OFFICE OF  
**FRESNO**  
**IRRIGATION DISTRICT**

November 30, 2010

RE: City of Clovis Northwest Urban Village – Draft Alternatives

DRIVE APPROACH IN URBAN AREAS

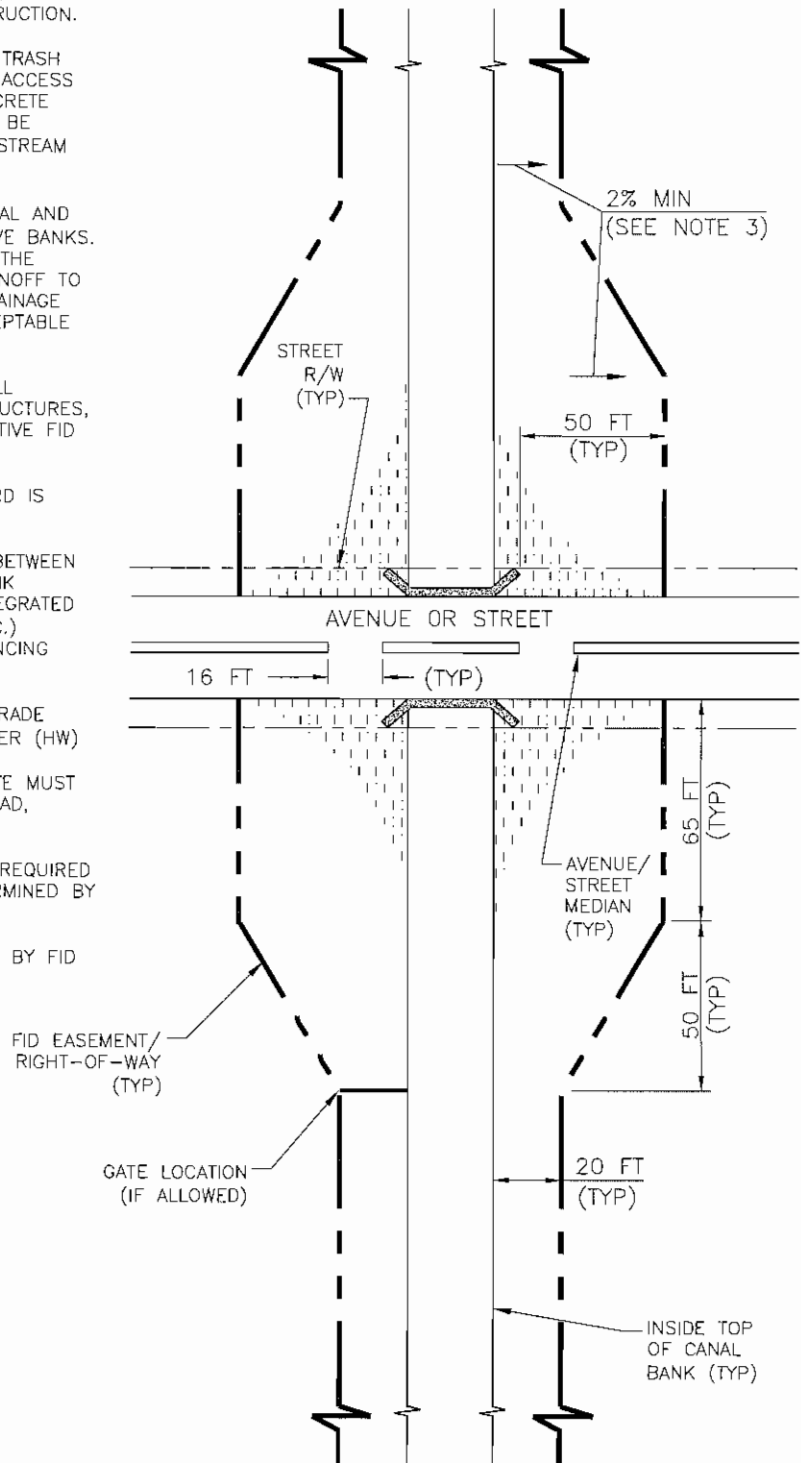
C. Canal Access - FID requires a 50-foot wide drive approach narrowing to 20 feet wide drive banks (See attached “Drive Approach in Urban Areas” Detail No. 62). The 50-foot width is defined as starting from the end portion of the bridge/railing outward (away from the bridge). The City has not recently supported this particular FID requirement, therefore a drive approach acceptable to all parties will need to be worked out if FID’s standard is not supported by the City. Every road and canal intersection is

different and therefore each access will be different. The major factors affecting the proposed width will be the angle of the road intersecting the canal, grade of canal bank vs. City road, median vs. no median, etc.
